REVISIONS 16/8/90

Drg. no. 901819 76

DAVID BROKER
ARCHITECTURAL AND
BUILDING TECHNICIAN
TELEPHONE 0945 81 421

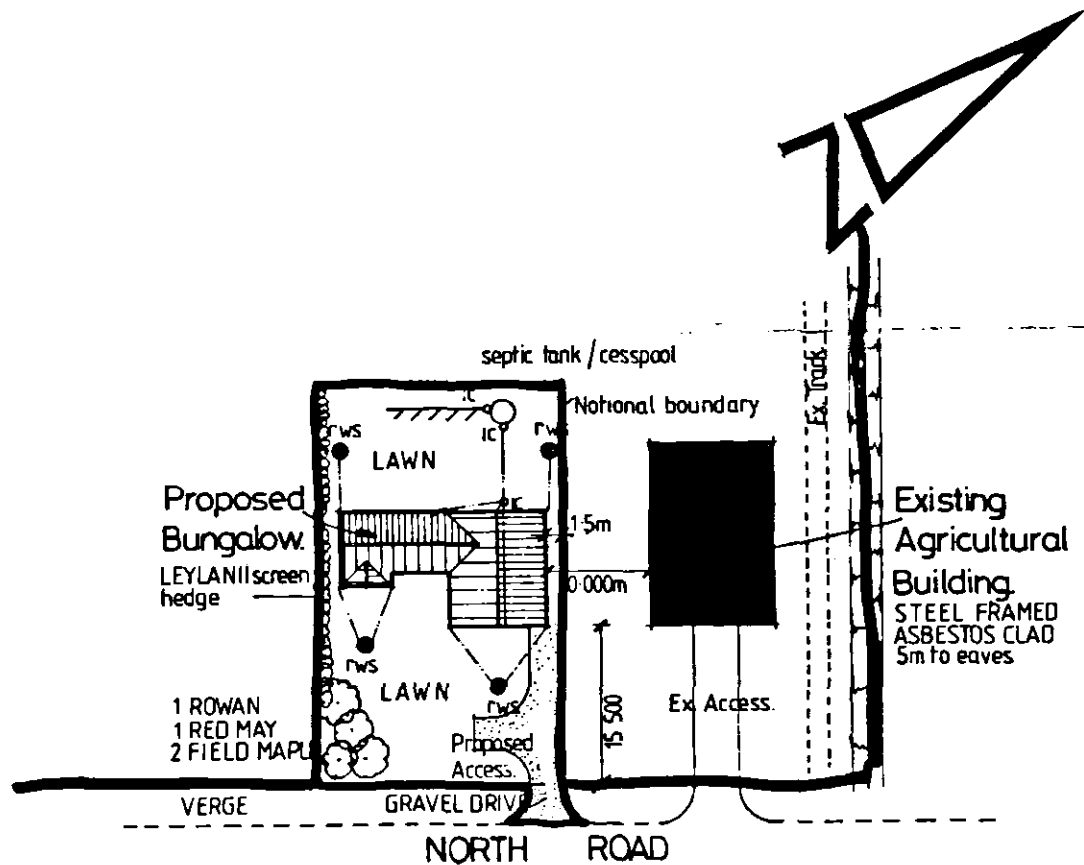
1. Manufacturers details for lintel supporting compound to be submitted to Council when received from Manufacturers Technical Services Department. Conditional Approval sought at this stage.

2. Existing agricultural building is single skin asbestos cladding, steel framed building @ 5,000 metres long.
3. See text notes.
4. All ventilable roofs to have background ventilation of 4,000m² per trickle ventilator, the ventilators should be controllable and secure and located so as to avoid draughts.

5. Where drains pass through a wall use Gurney or similar wall protection sleeves.
6. See plan.
7. Air bricks to provide an open area equivalent to 50% of the appliance throat area.

8. The flue should not have any offset greater than 30° to the vertical.
9. The whole of the limbs to the fire place recess to have min. width of 200mm.

10. I.e. Lintels are backed with expanded polystyrene as standard. Jambes and sills to be insulated using insulating cavity closures.

11. Ground floor to be insulated to provide a U value of 0.45 m²/k. See section on plan.
12. Lay 150mm insulation (fibreglass) between joists giving a U value of 0.25/m²/k.
13. All windows to be double glazed.
14. A thermostat is to be provided to keep the water at required temperature, for all hot water storage vessels. A time switch is to be provided which will shut off the supply of heat when there is no hot water demand, for a hot water vessel within a capacity of more than 150 litres, which is not heated by off peak electricity.
